# WACONIA PLANNING COMMISSION MEETING AGENDA

<b>Meeting Date:</b>	July 10, 2025
<b>Item Name:</b>	4.1. PUBLIC HEARING - Site Plan and Design Review, Variance & Conditional Use Permit (CUP) - TMC Properties - 1370 Mill Lane
<b>Originating Dept:</b>	Community Development
<b>Presented By:</b>	Lane Braaten
<b>Previous Council Action:</b>	
<b>Item Type:</b>	Regular Session
<p><b>RECOMMENDATIONS/COUNCIL ACTION/MOTION REQUESTED:</b> Open Public Hearing          Close the Public Hearing          Provide recommendation to the City Council regarding the Site Plan, Design Review, Variance and Conditional Use Permit applications submitted by TMC Properties, LLC for the property located at 1370 Mill Lane.</p> <p><b>EXPLANATION OF AGENDA ITEM:</b></p> <p><b><u>BACKGROUND</u></b>  <b>Applicant:</b> Nick Hansen  <b>Owner:</b> TMC Properties, LLC  <b>Address(es):</b> 1370 Mill Lane  <b>PID#</b> 755160110  <b>Existing Zoning:</b> I-1, Industrial Park District  <b>Design District:</b> Industrial District</p> <p><b><u>REQUEST</u></b>          The applicant, Nick Hansen, TMC Properties, LLC, has resubmitted a Site Plan and Design Review application, along with Variance and Conditional Use Permit (CUP)

10 C5 PEDESTRIAN RAMP  
NO SCALE

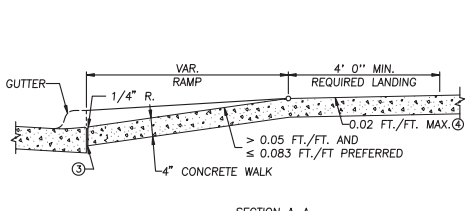
21. The concrete pedestrian ramp near the front entrance of the building is recommended to be ADA compliant and contain truncated domes.
22. The landscaping plan shall be reviewed to confirm the proposed planting locations do not conflict with the proposed storm sewer pipes at the connection to Mill Lane, the OCS location, and the 12" inlet near the northeast corner of the building.

15 C5 IRON-ENHANCED FILTRATION BASIN CROSS SECTION  
NO SCALE

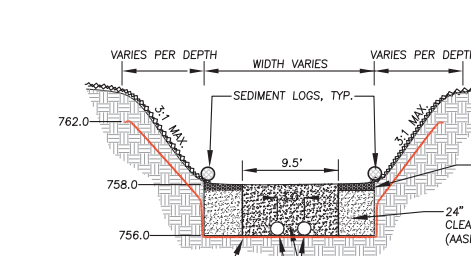
- c. The location of the Iron Enhanced Sand Filter (IESF) and bioretention basin should be indicated on the plan with hatching to show where specific sections are to be installed. A profile should be provided for the length of the basin through the outlet structure to verify design and ensure the system is constructed as proposed. The IESF detail provided does not match the Carver County Water Management Organization (CCWMO) requirements, and a detail for the bioretention filter area shall also be added. Details shall be coordinated with the CCWMO.

- d. The 40 mil liner should be removed from the detail. Even though infiltration may be hindered by the tight soils, the liner is unnecessary.
  - e. Calculations for reduction in TSS and TP shall be submitted for City records. These reductions can be included in the overall Waste Load Reductions required by local TMDLs and should be recorded in the City's SWPPP as well.

PRELIMINARY  
EXTERIOR ELEVATIONS  
SITE PLAN - OPTION D

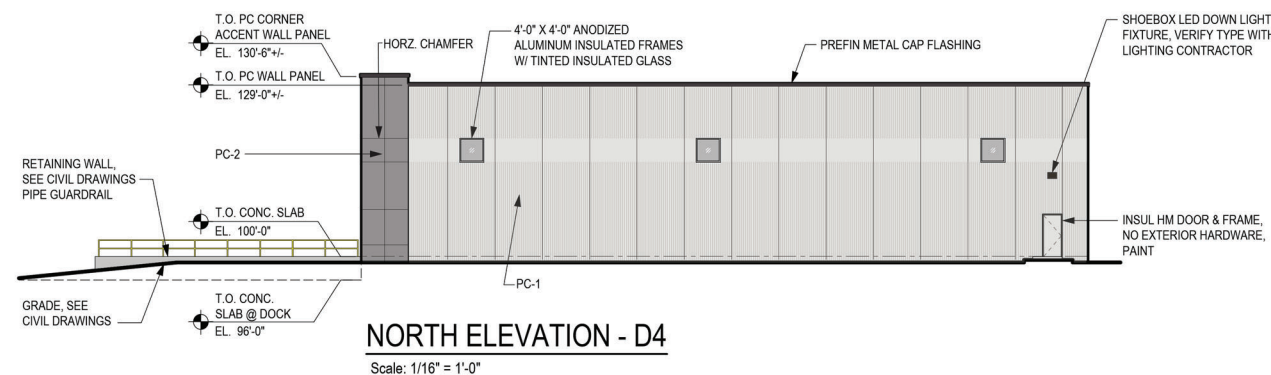
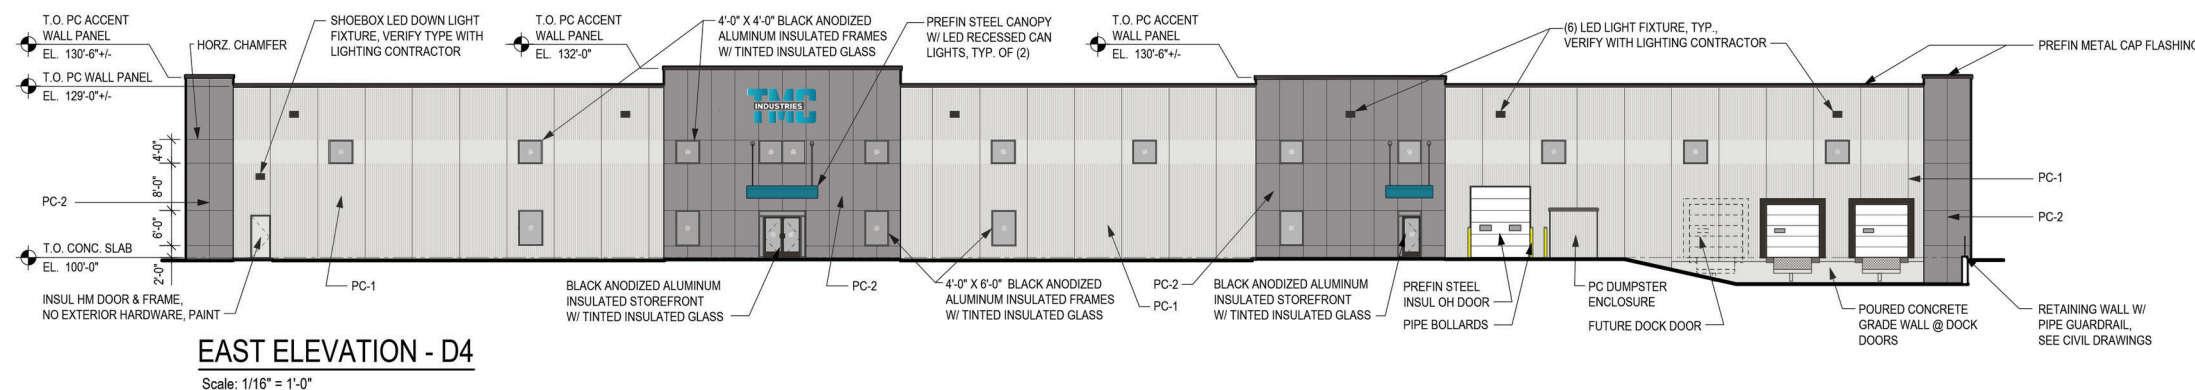
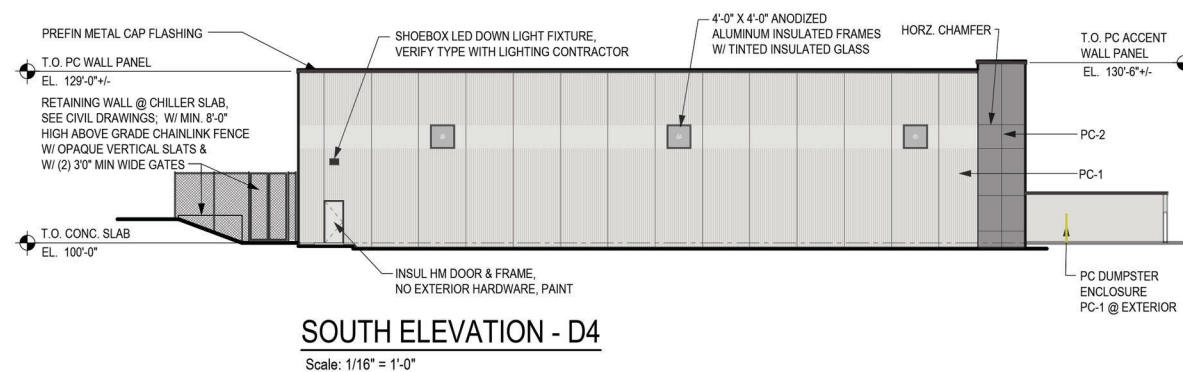
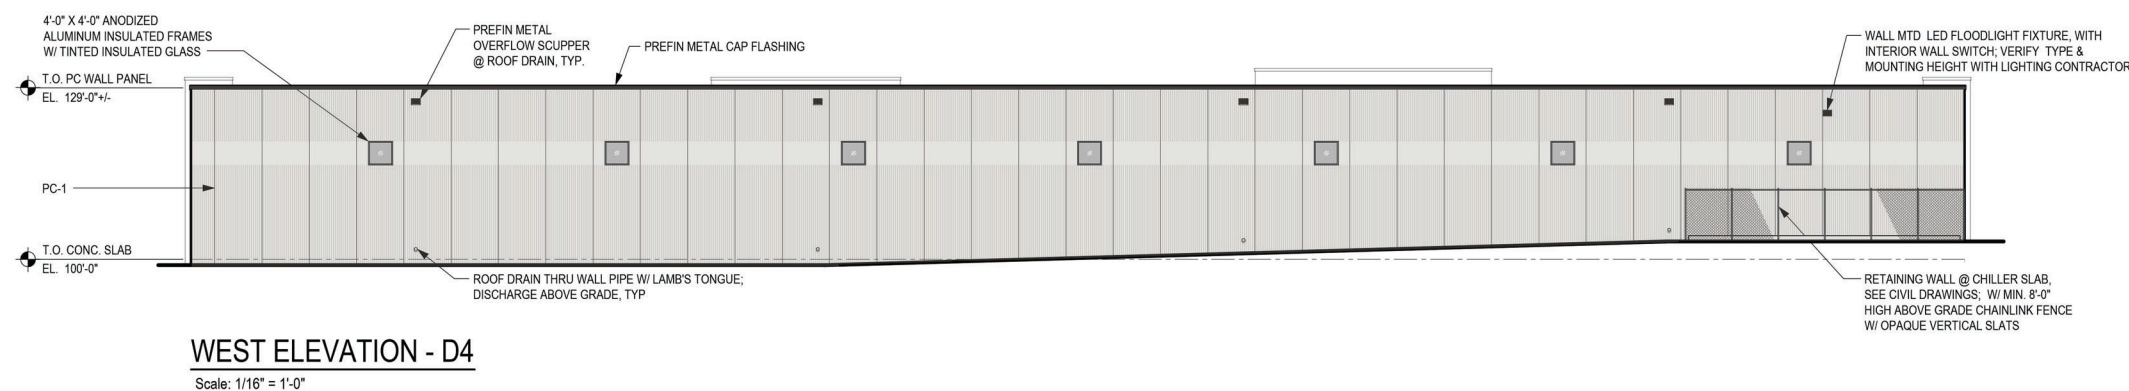
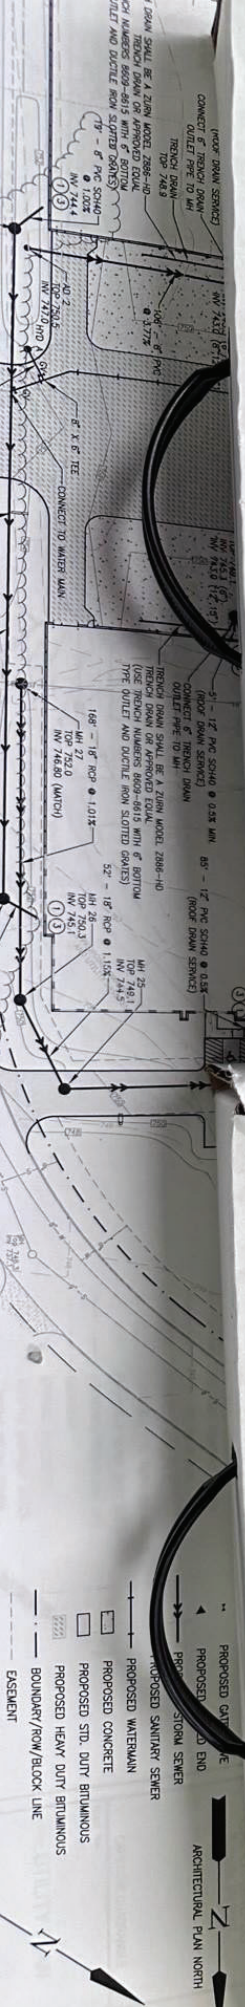
Sheet No. P2 – Preliminary Exterior Elevations Site Plan – Option D indicates a “PC Dumpster Enclosure PC-1 @ Exterior”. The dumpster enclosure is located on the front side of the building near the loading berth/dock areas. Based on the description it appears that the enclosure will match the proposed building materials, which is consistent with City Code requirements. Additionally, the applicant shall be required to install a screening gate to fully enclose the dumpster location and totally screen the dumpsters from view consistent with City Code. The gate screening material shall be consistent with the design of the building and dumpster/trash enclosure.

6. The trash enclosure shall be constructed of the same, or similar material, to the principal structure and shall include a gate fully screening the trash/dumpster area. The gate materials shall be submitted for review and approval prior to work commencing on site.
